Arlington High School Building Committee
Finance Subcommittee Meeting
Tuesday, September 19, 2023
Conducted by Remote Participation
4:00 PM – 4:30 PM
Agenda

**9/19/2023 AHSBC Finance Subcommittee Meeting
Meeting Materials**

Change Order (CO)

Revisions at Part a regarding routing of various condensate drains (refer also to RFI-753):

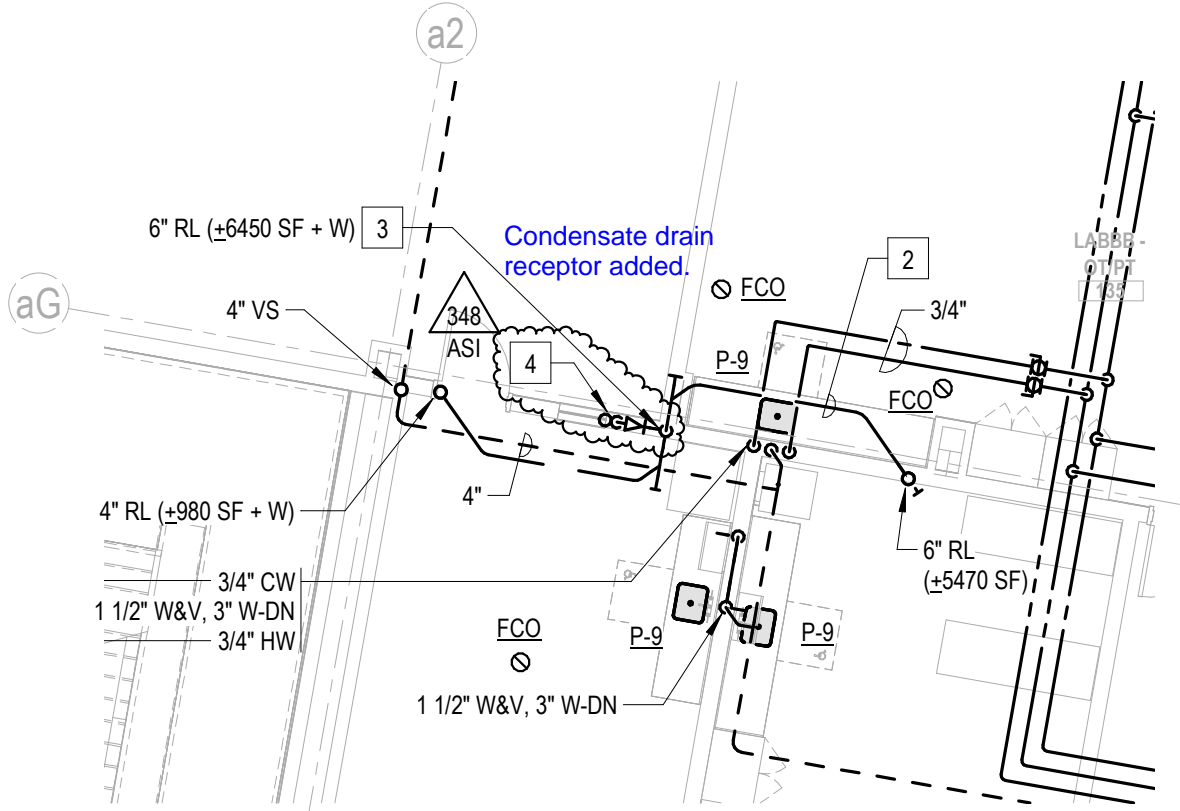
Refer to Sketches SKP-037: Added condensate receptors at two locations.

Refer to Sketches SKM-107a,b,c: Revised routing, showing of routing of condensate drains.
Added three pumps.

Arlington High School
PLUMBING AREA A REVISIONS

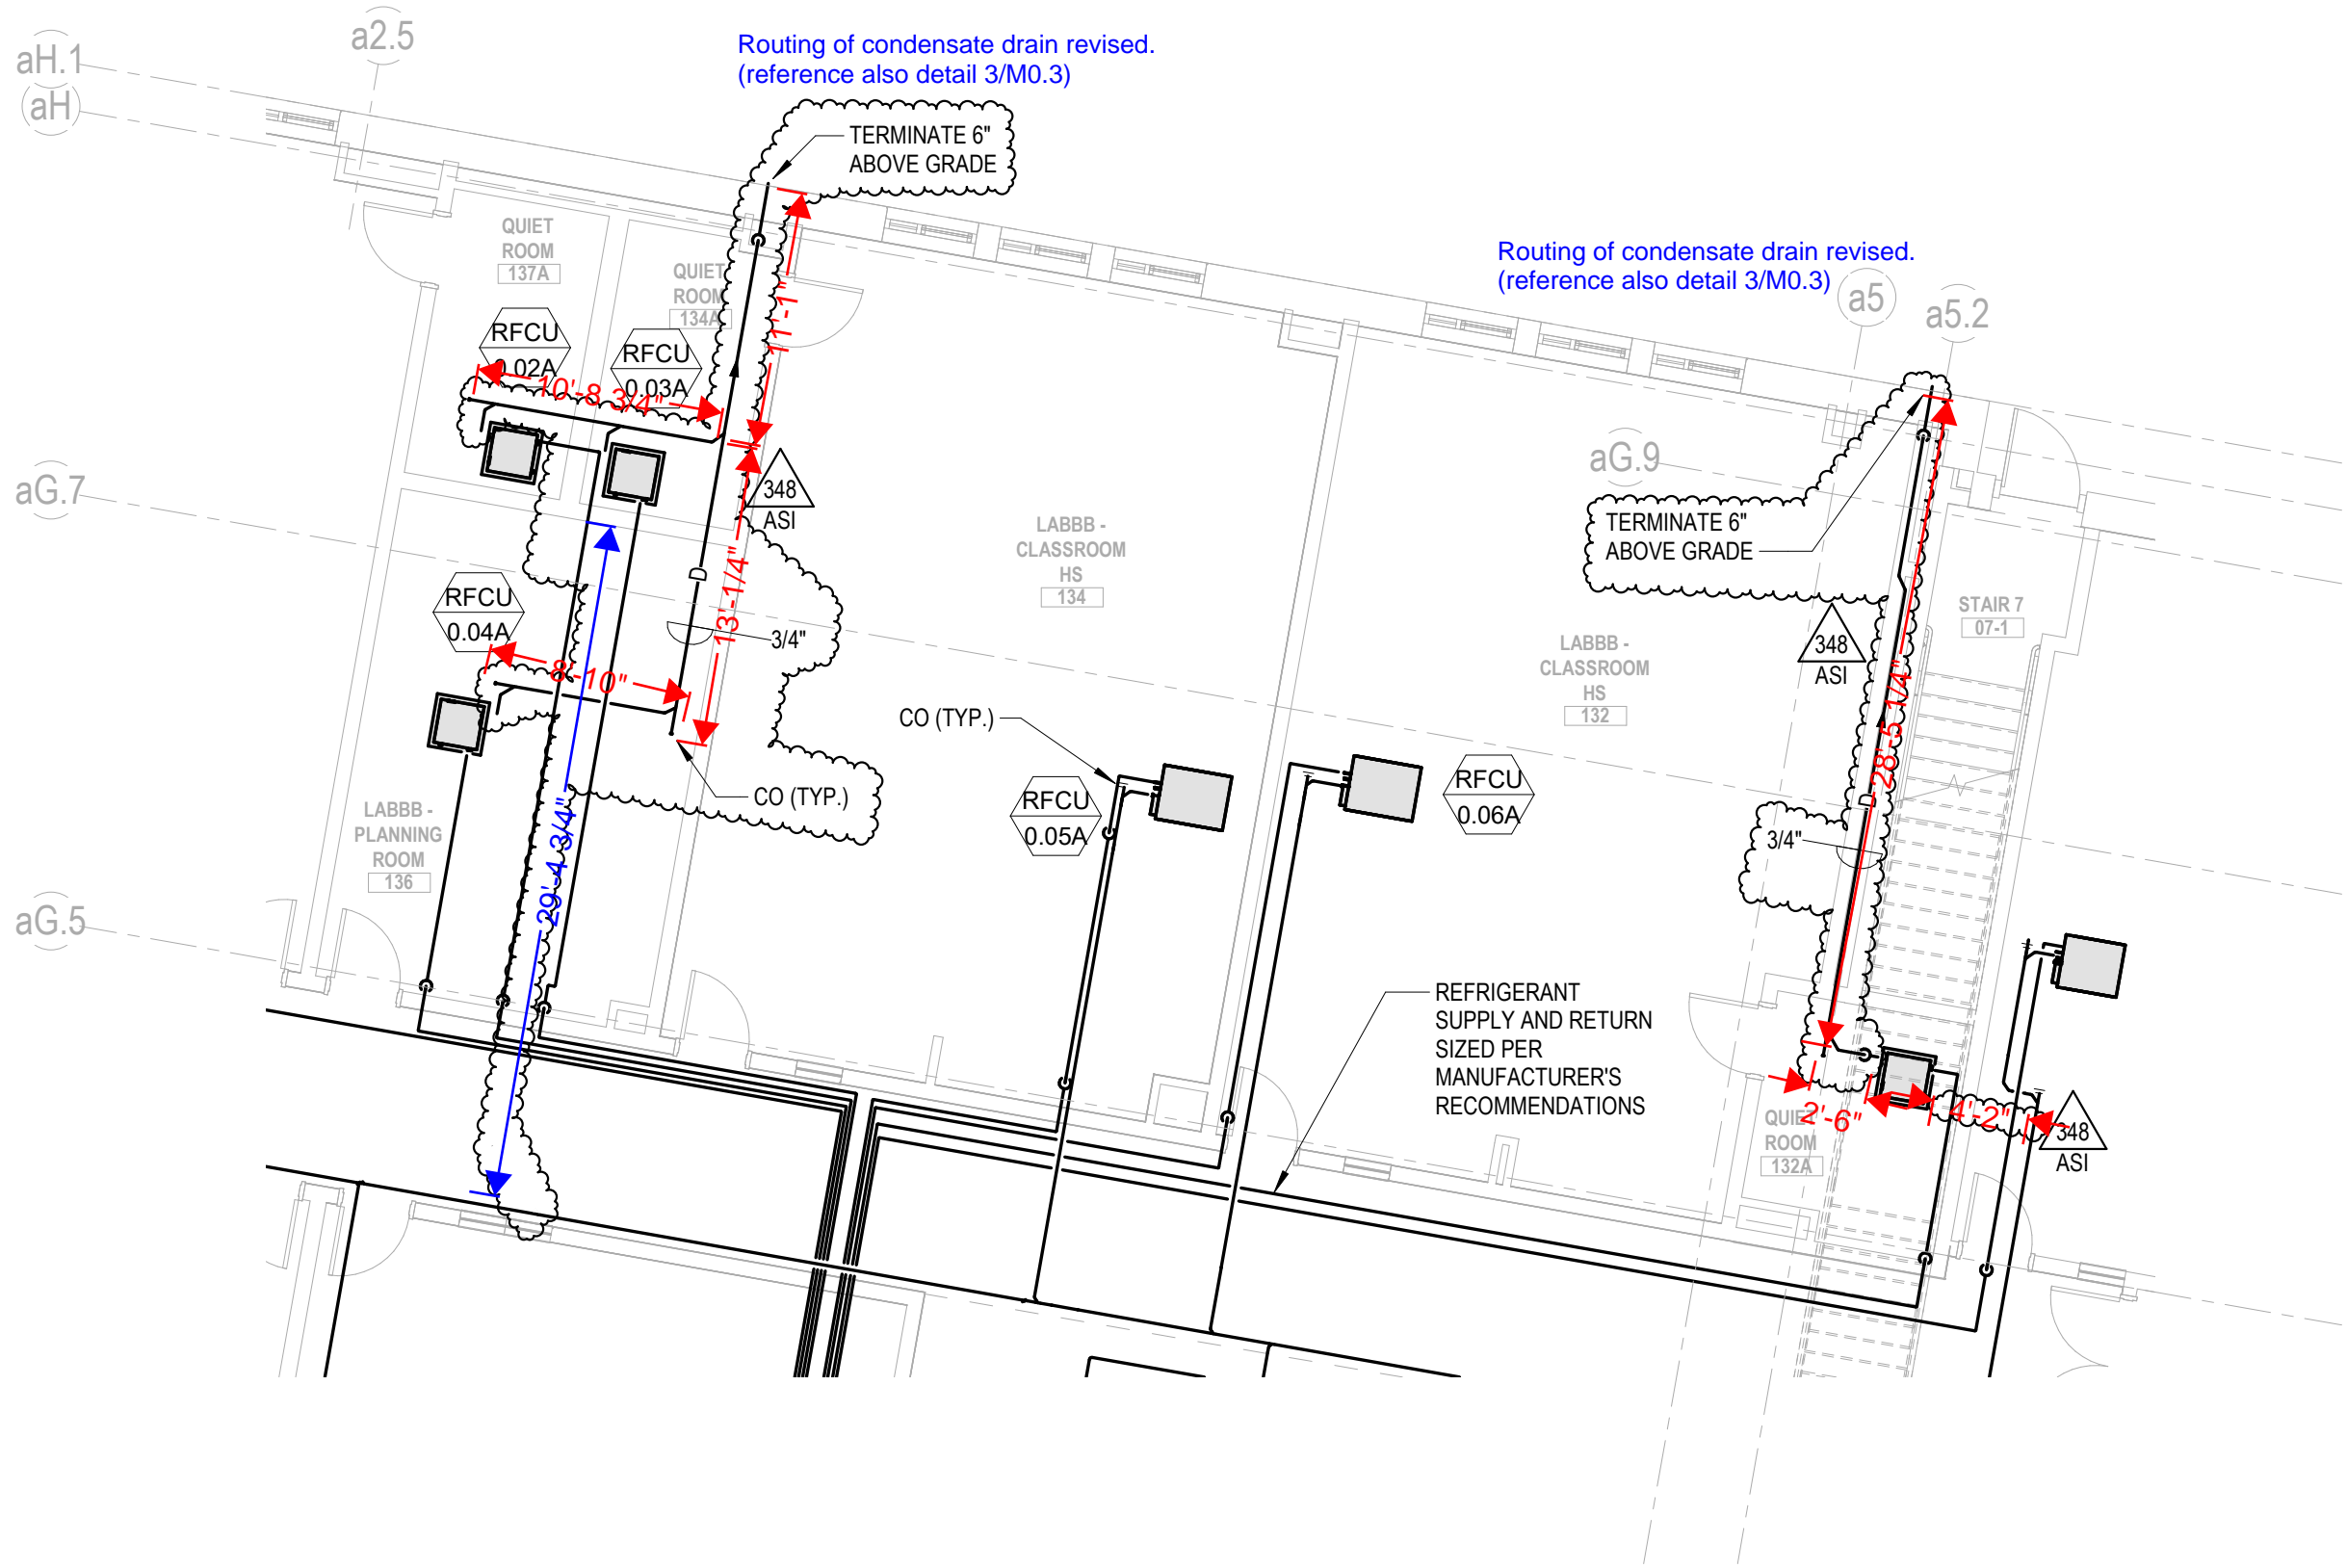
See also RFI-753
REF. DWG. P 2.0a ASI-348

CCC - CR618R1
DRAWING NUMBER
SKM
107a
JOB NUMBER
6017442

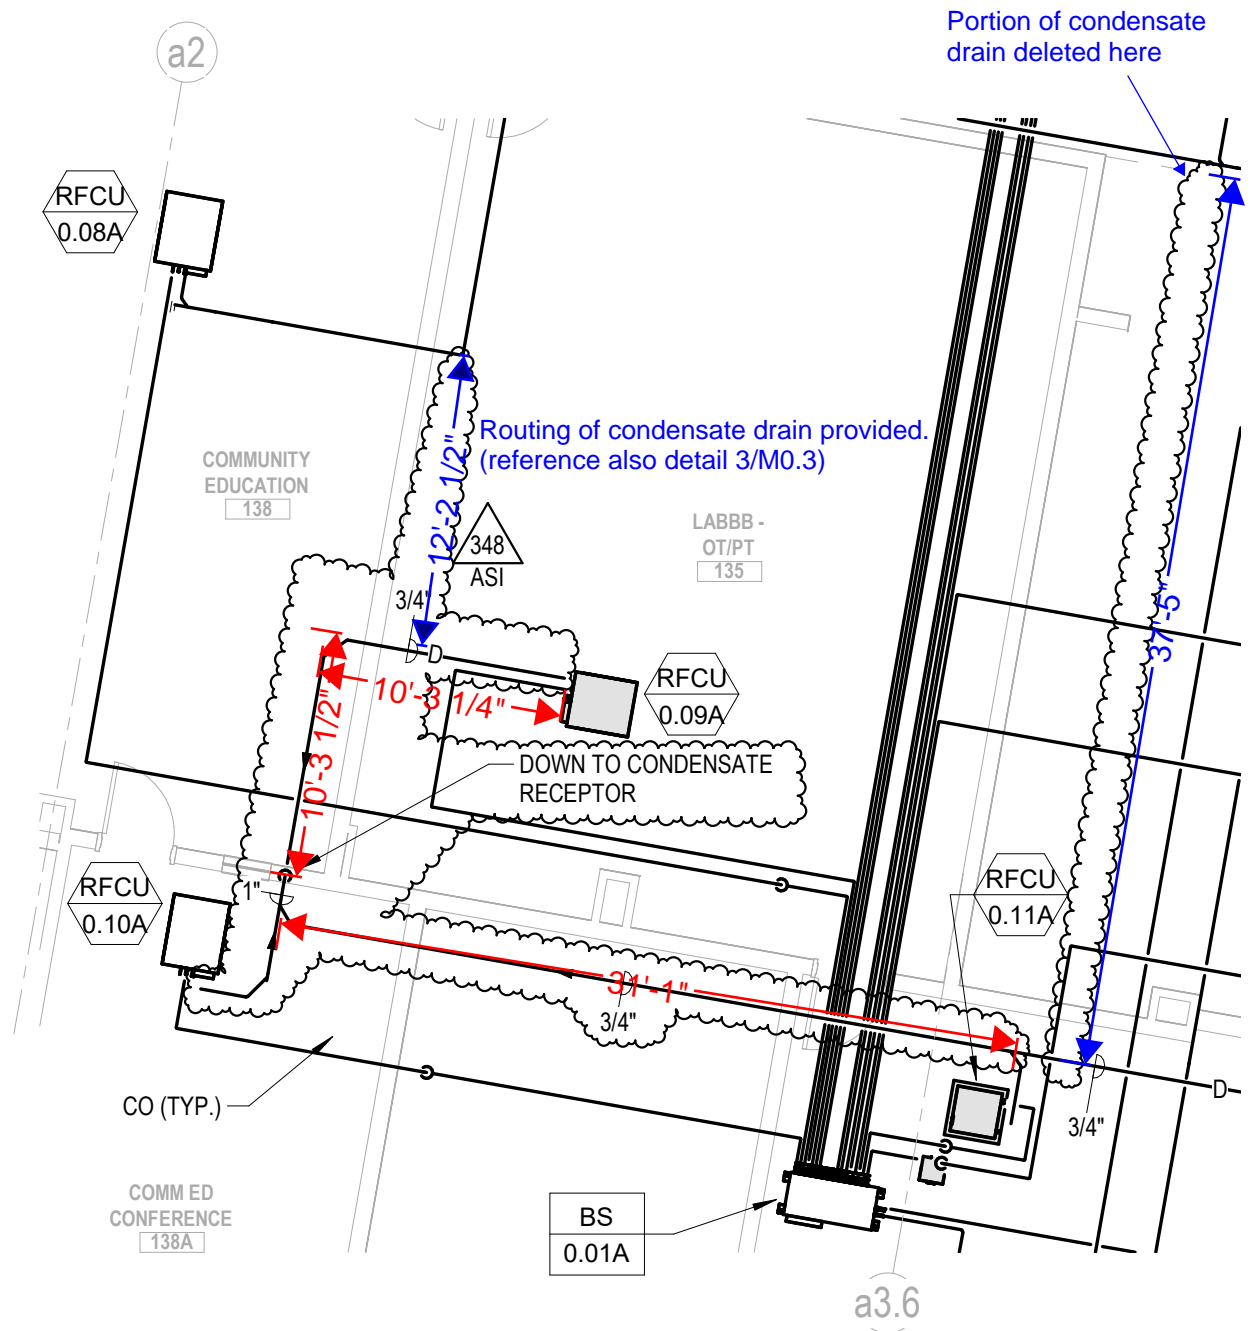
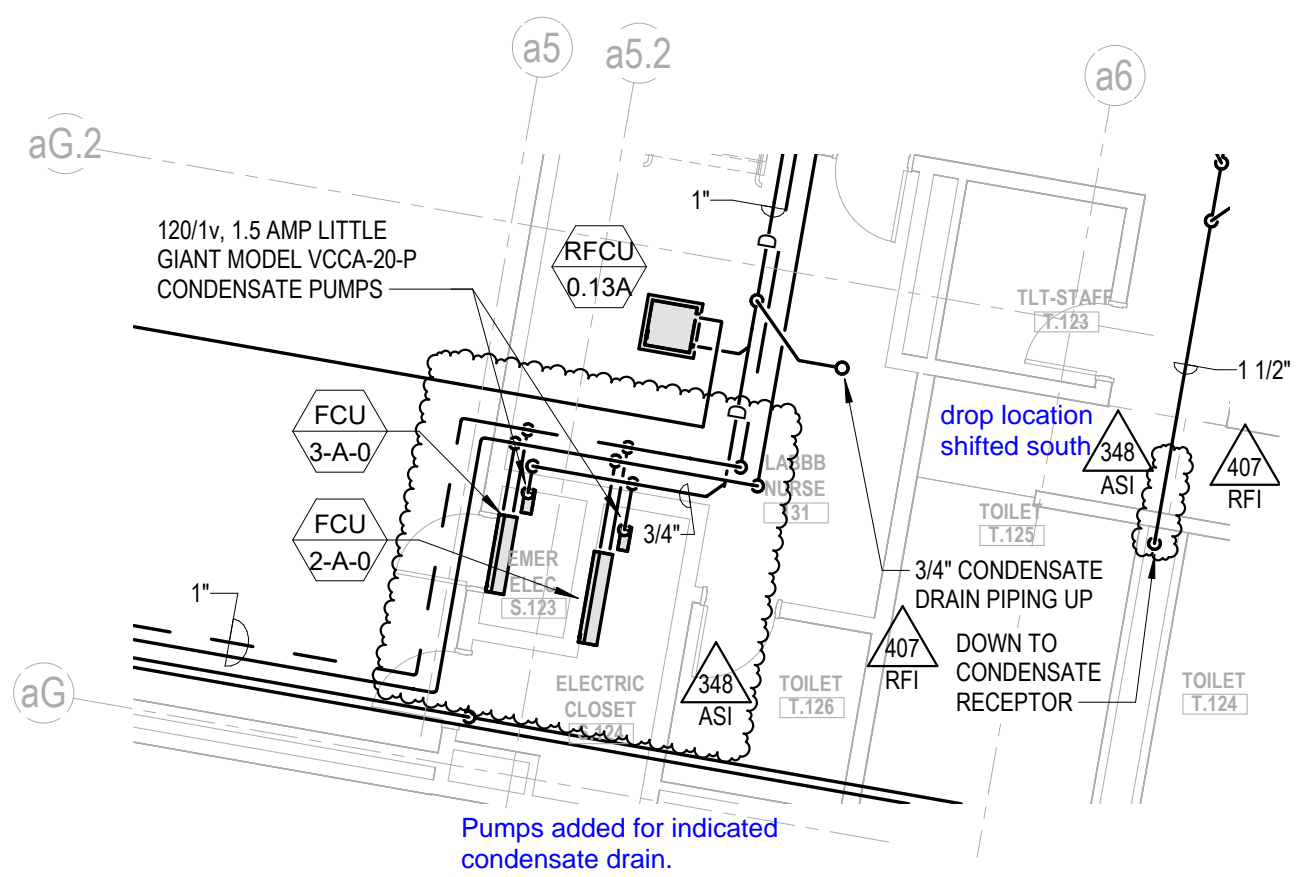
See also RFI-753
REF. DWG. M3.0a ASI-348

PIPING REVISION 1ST FLOOR A

PIPING REVISION 1ST FLOOR A

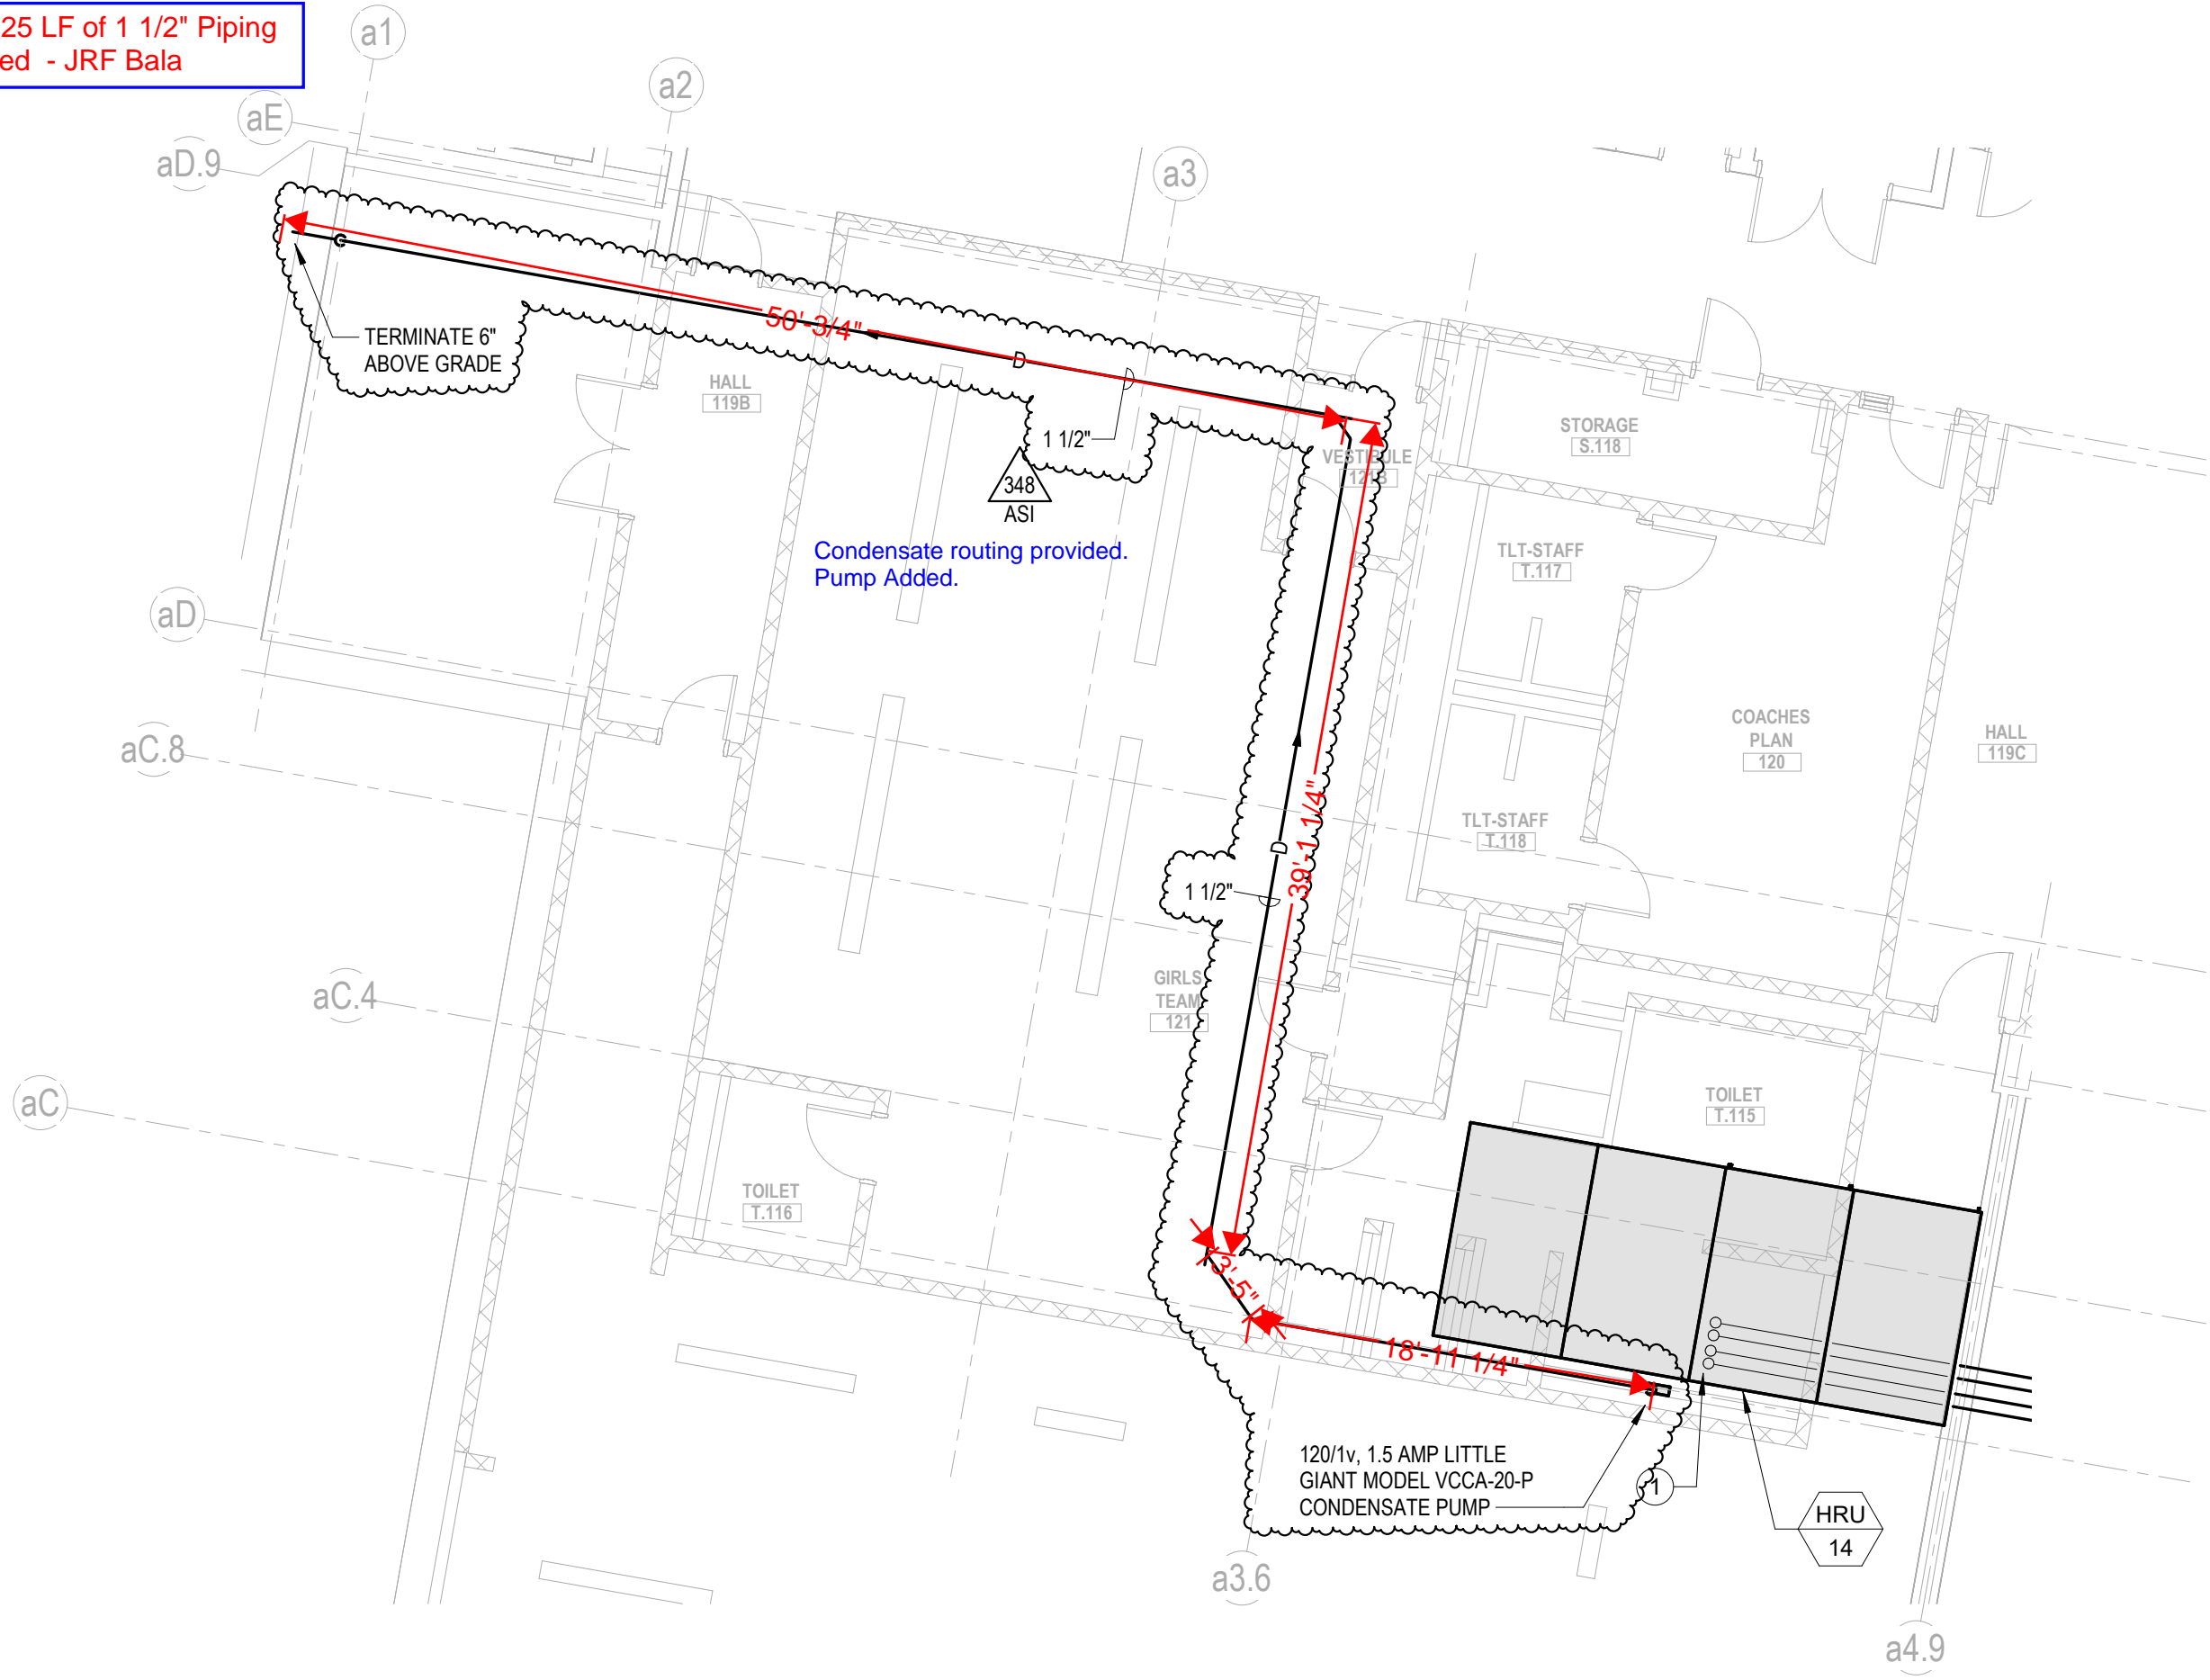
See also RFI-753
REF. DWG. M3.0a ASI-348

+/-125 LF of 1 1/2" Piping
added - JRF Bala
